# Groundwater Transfer Review Summary Form

Transfer/PA # T- 14402

Application: T-14402

Applicant Name: Broken Top Community Club

Hydrograph 2 - Groundwater level elevations across all wells on transfer

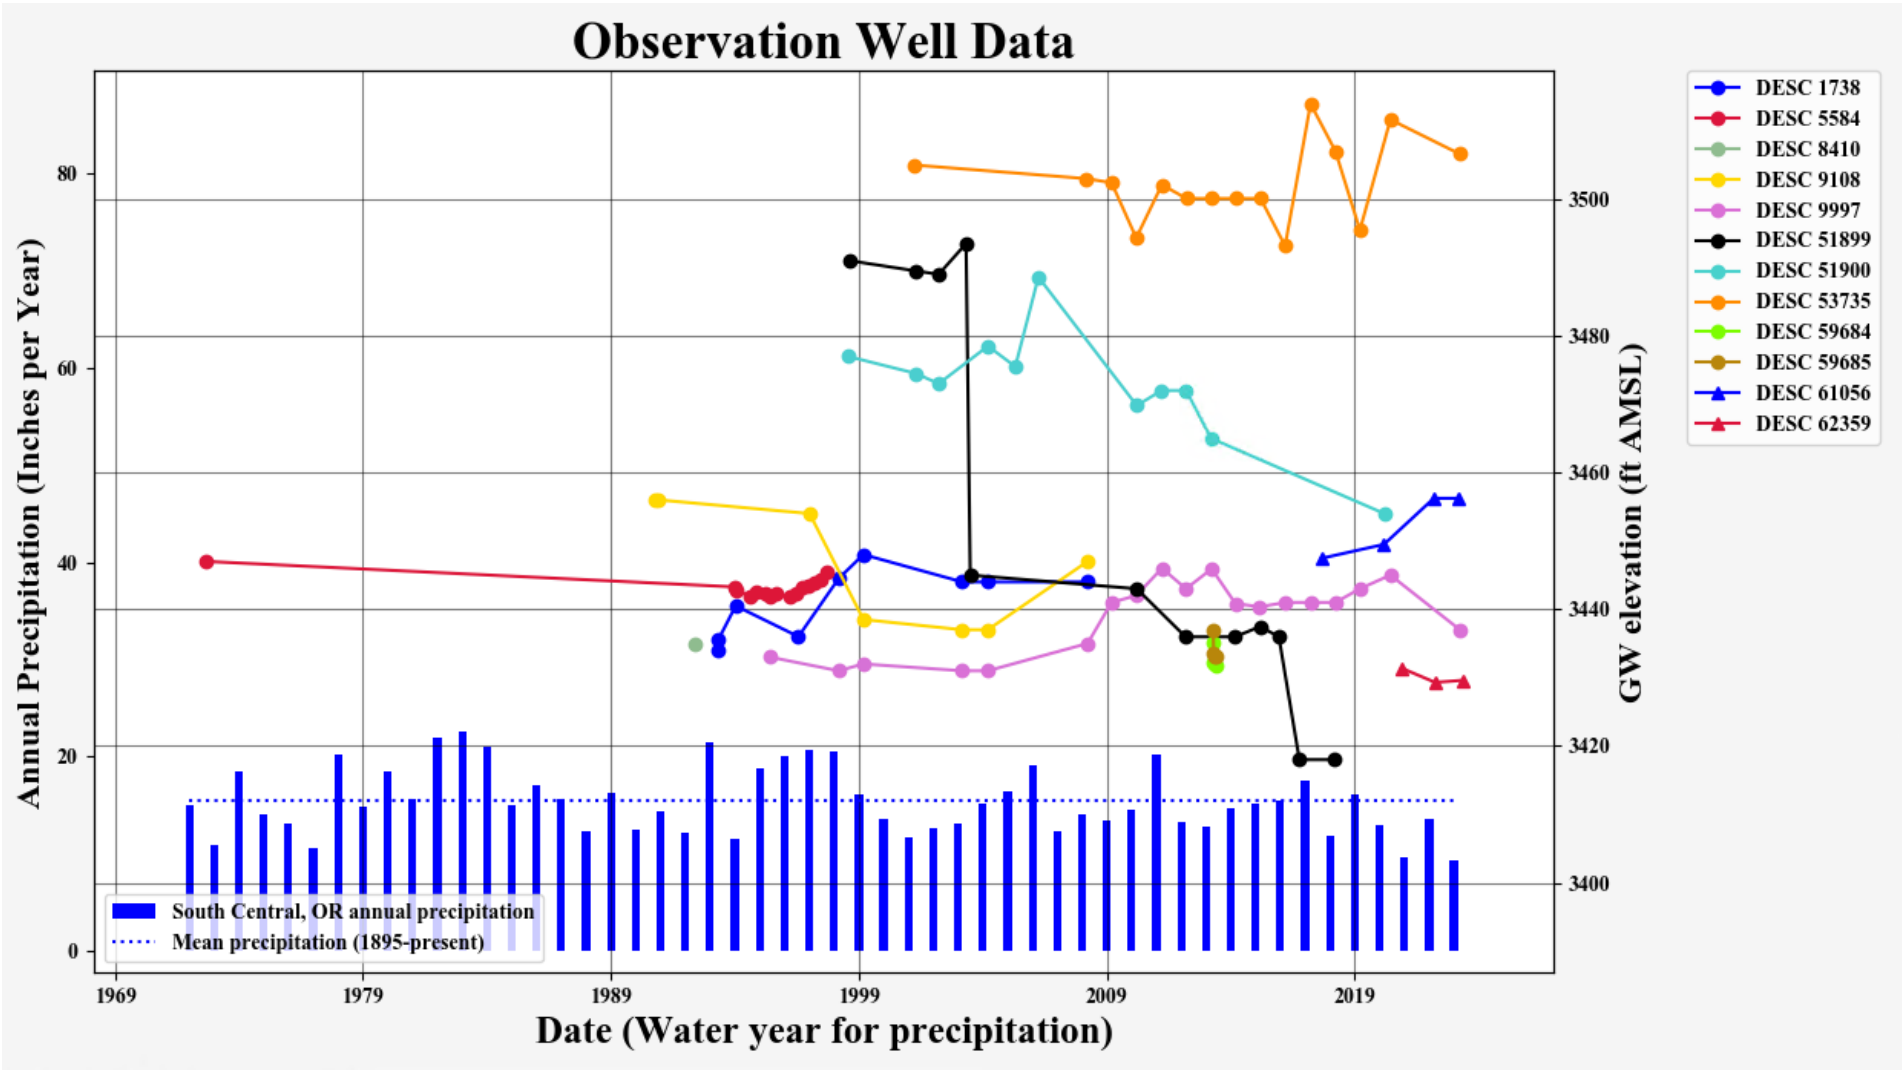
8. Any additional comments: Current transfer rules do not directly consider whether the proposed changes would increase groundwater pumpage in areas of groundwater declines. Still, it should be noted that the Dyer well group are in an area of the Deschutes regional groundwater system that has experienced persistent, year-on-year declines since the mid-1990s.
